ASHLAND PLANNING DIVISION
PRE-APPLICATION CONFERENCE
COMMENT SHEET June 14, 2022

SITE: 1955 Ashland Street
APPLICANT: KSW
REQUEST: Site Design Review

Summary: This application is for a two-story addition to the existing building. Details on the proposed building are minimal so some comments will be general in nature.

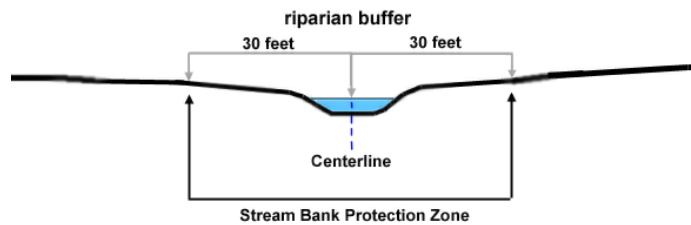
WRPZ The drainage on is an identified "Intermittent and Ephemeral Stream" and has a 30' buffer as shown at right.

Among other allowed uses are "Routine Planting. - The planting of local native plant species or the replacement of non-native, noxious and invasive plants with local native plant species is allowed"
